**PRELIMINARY GEOTECHNICAL ENGINEERING STUDY
 WATERMARK AT COLORADO SPRINGS
 AKERS DRIVE APARTMENTS
 NWC OF CONSTITUTION AVE & MARKSHEFFEL RD
 COLORADO SPRINGS, COLORADO**

Project No. 20-2-194

September 10, 2020

Soils V_1 planning only.pdf Markup Summary 3-17-2021

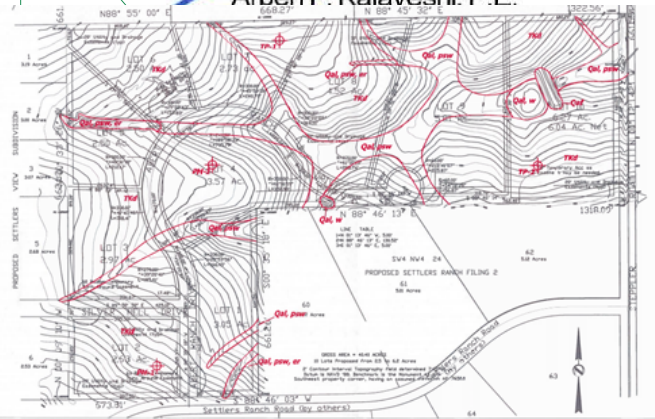
Provide a map depicting the constraints and hazards over the site pln, and or plat area so we can determine which buildings, ponds and pool are impacted

Provide soil survey map
